UINTAH MOUNTAIN COPPER COMPANY

Re: Responses to Letter of 4/16/01 & Meeting of 5/10/01

## Supplemental Information for USFS Letter of 4/16/01 and Meeting on 5/10/01

# MAP 3

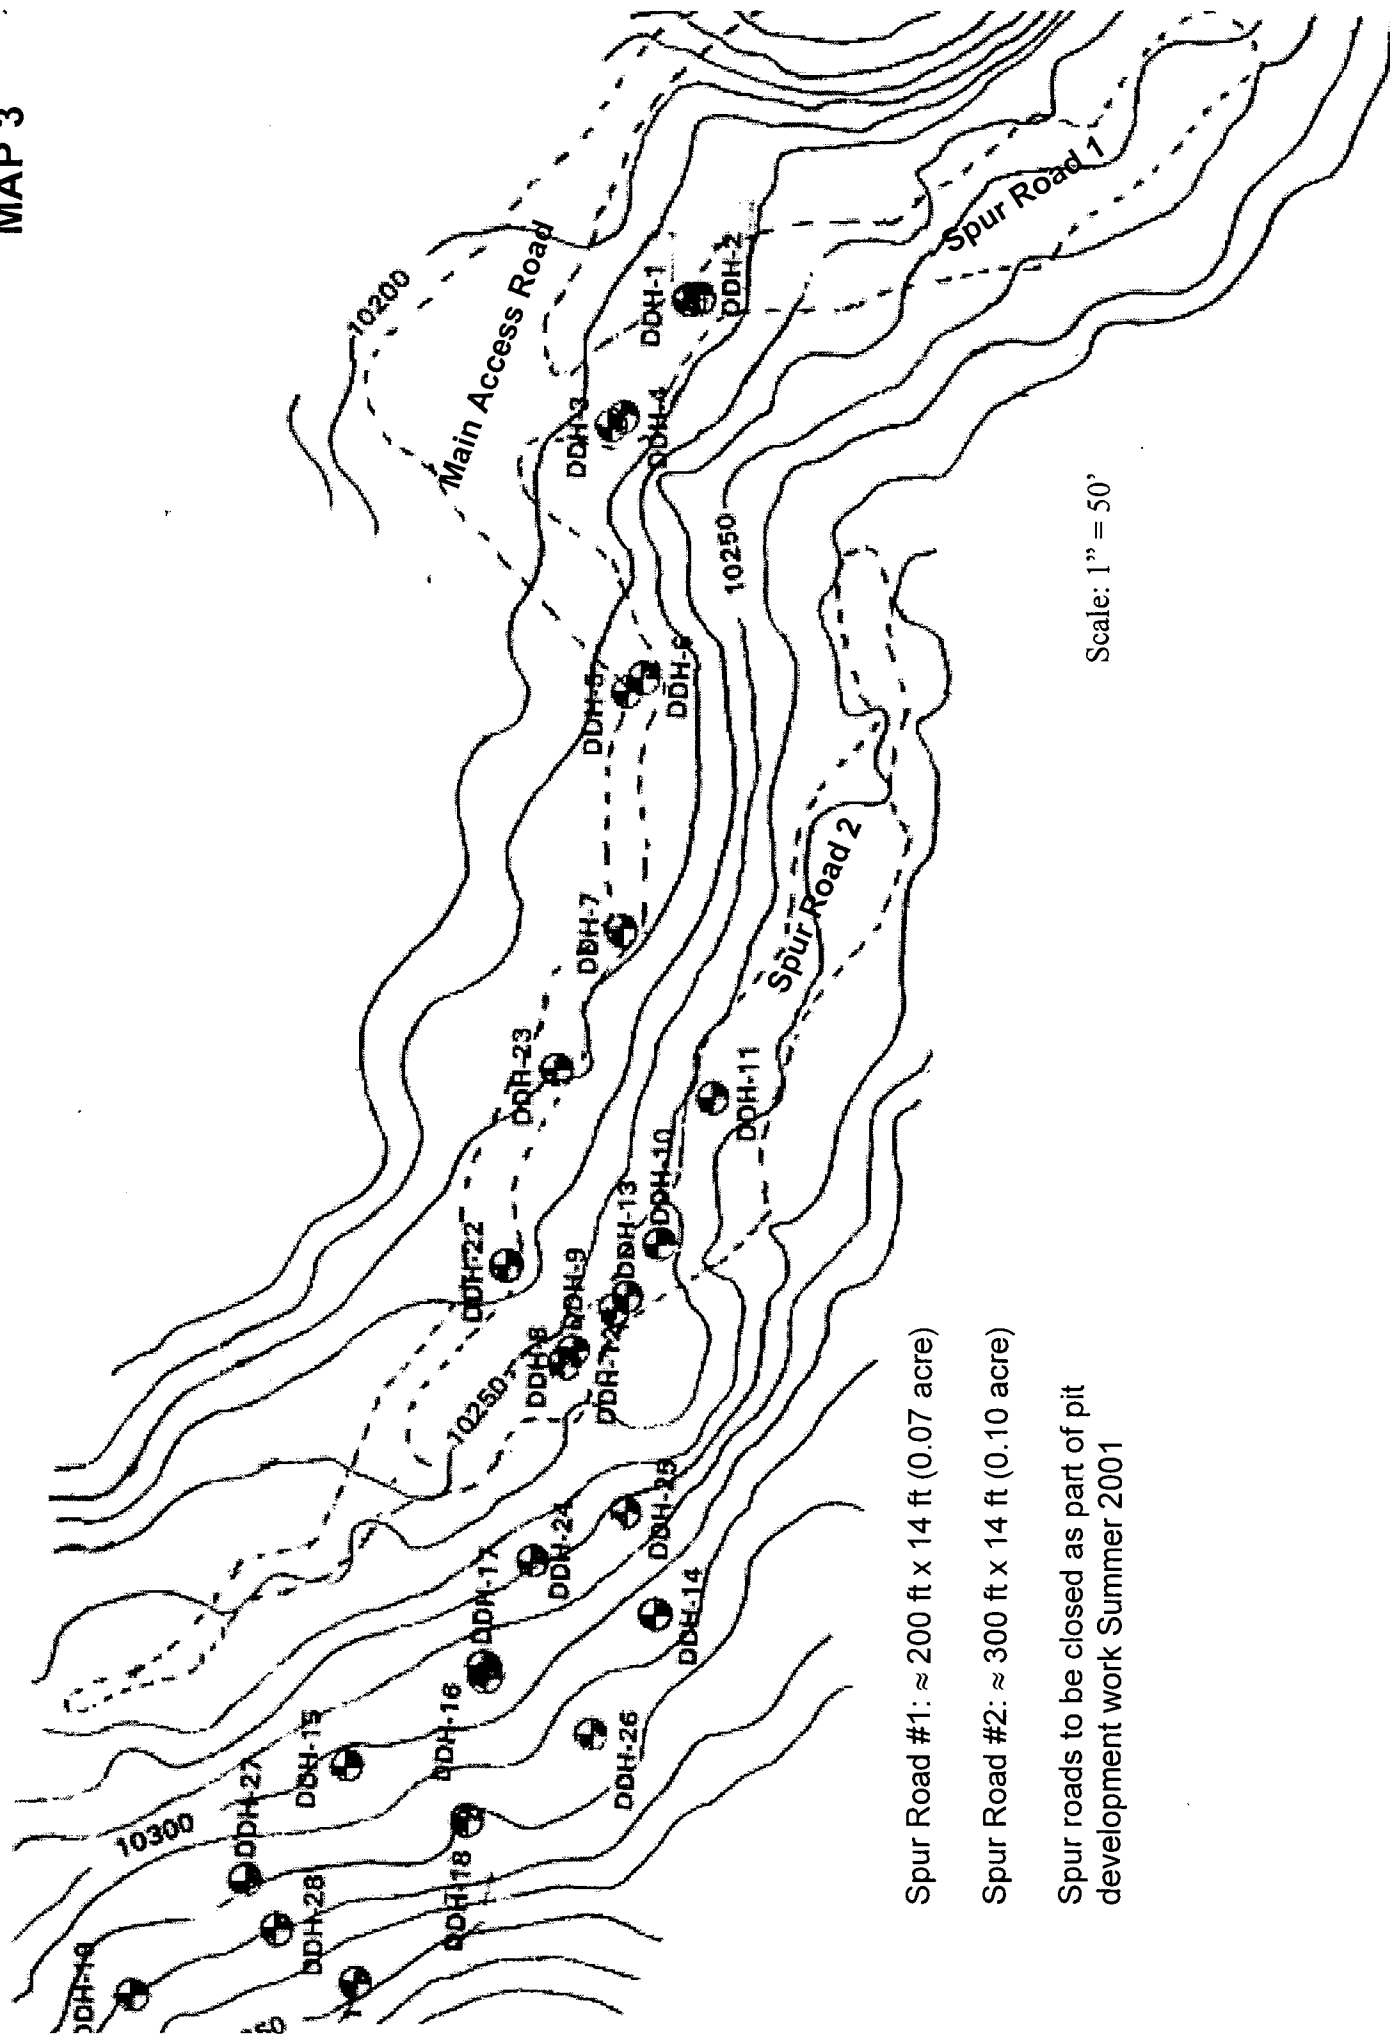
### Item 2 – Overburden Storage

Section E of the POO Supplemental Discussion provides the basic description of the 2000 cubic yards of overburden and topsoil storage location for the test pit project. The POO notes an area 250 feet long and 10 to 15 feet wide for storage. As identified by the IDT, this would be inadequate for the expected volume. After reviewing the site map, it was found that an incorrect road length was reported in the POO. The access road in this section of the work is over 400 feet long and varies from 10 to 15 feet in width. In addition, approximately 600 cubic yards of overburden will be stored and processed for gabion/drainage rock along the 200 foot long by 15 foot wide Spur Road #1. This will allow the remaining 1400 cubic yards of overburden to be stored along the road (400 feet long, 12.5 feet wide, 7.5 feet deep). Map 3 provides a scaled map of the proposed areas.

**Figure A**

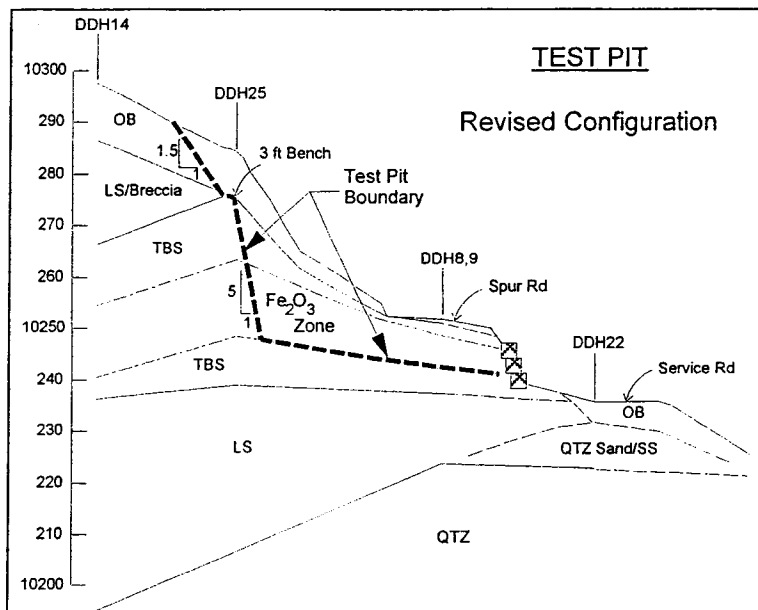
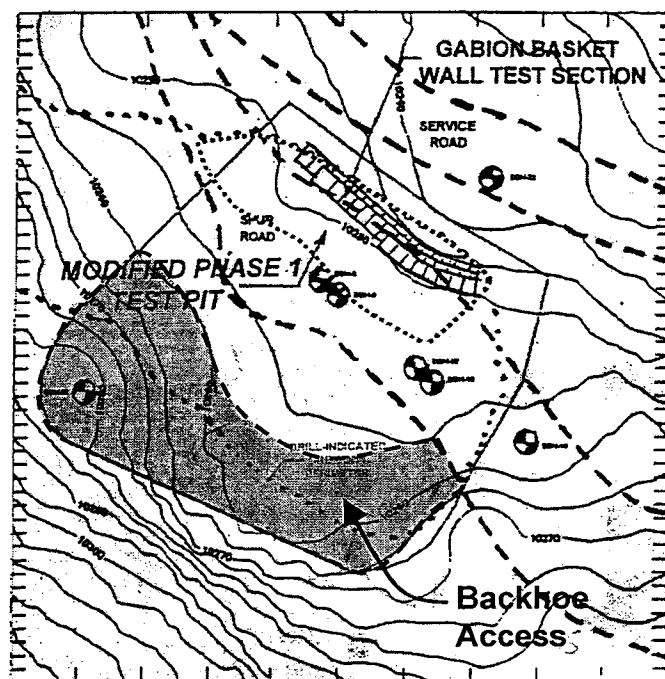
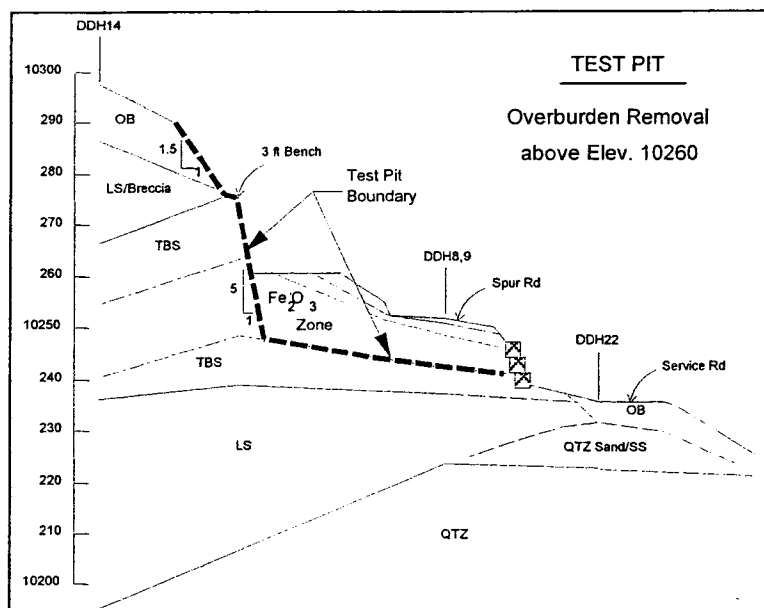
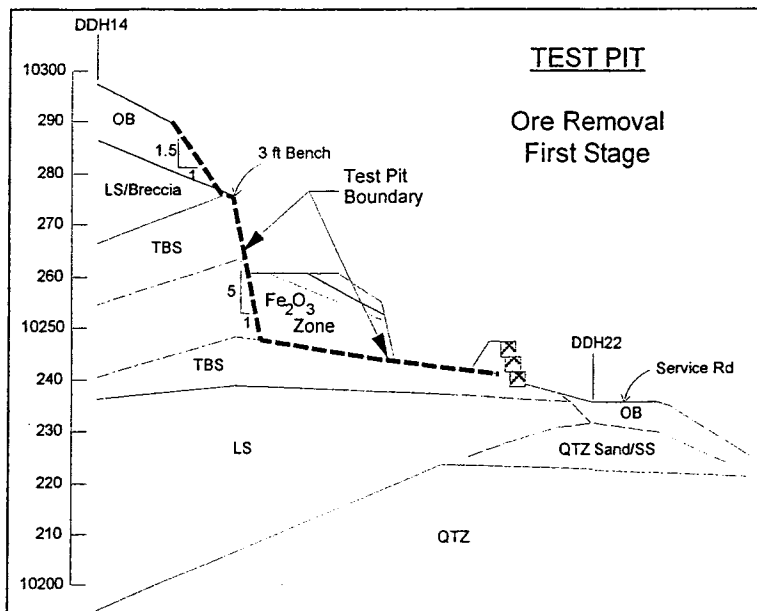
Per the recent IDT meeting on 5/10/01, UMCC agreed to modify the pit configuration to satisfy USFS engineers concerns on stability and constructability. In general, this revised reclamation slope eliminates the two upper gabion terraces, broadens the second terrace to provide a catchment for loose soil and rock, installs a rock net along exposed rock faces that can be vegetated, and extends the gabion walls into competent material to prevent side erosion. Backfill layers will also include a drainage and filter system to

prevent the buildup of hydrostatic pressures and geogrid reinforcement to improve the stability of the reclaimed slope. The fourth paragraph of POO Supplemental Discussion is modified as follows (see attached modifications to Figures A through D):

The pit will be backfilled by following the process in reverse and using the adjacent spur road for access to the upper reaches of the cut (Figure C). Overburden will be placed behind the existing gabion (one additional basket lift will be placed at the time of fill) to the base elevation of the next higher gabion system (Elev. 10255). A one foot thick drainage layer will be placed along the bottom and sides of the excavation. This layer will be covered with a filter fabric to prevent migration of fines from the remainder of the backfill. Geogrid layers (Tensar type) will be placed along the top of the drainage filter and laterally at each gabion lift. The second wall system will be placed to a final elevation of 10264, in the same manner as the first wall system. The terrace created by backfilling behind this wall will be sloped back slightly to the rock face to create a catchment for rock and soil from upper elevations. Upon completion of the second wall system, a rock net will be installed along the remainder of the open cut rock face (as shown in Figure D). Once all upper level work is complete, the existing lower gabion wall will be extended to the northwest, with final backfill placed from the access road by use of the excavator.

**Road Bed Rock Underdrain**  
Low Section Drainage (NTS)

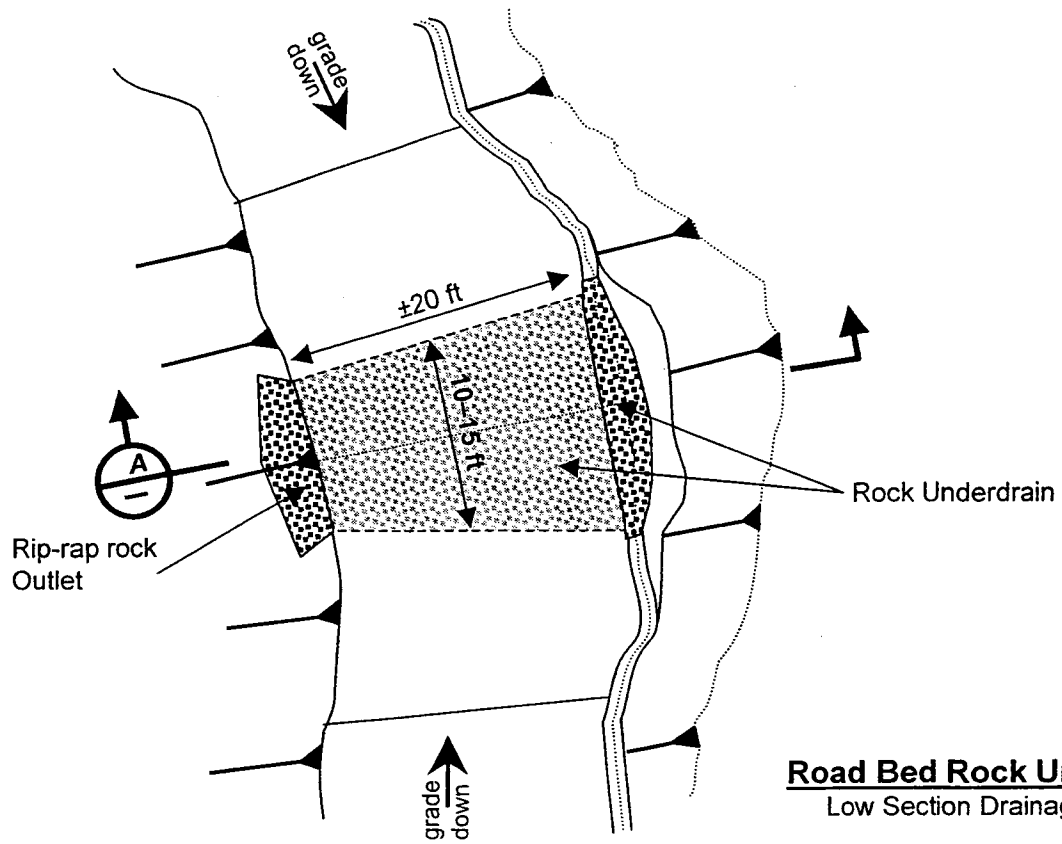
During the meeting of 5/10/01, USFS representatives noted that drainage problems exist on a section of road within the upper 1800 feet to the test pit site. UMCC agrees to improve drainage along this section using methods identified in the standard details proposed for Water Quality issues from the 11/30/00 supplement. Specifically, water bars will be constructed as directed by the USFS to remove water to the outer edge of the road and prevent collection of storm waters at erosive sections. Low points and outflows that collect water will be protected with rip-rap rock to prevent erosion. At these locations, water will be allowed to cross through the rock drainage blanket, flowing under road beds. Filter fabric will cover the rock drain and a road bed will be reconstructed above. A detail showing this type of erosion protection is attached.
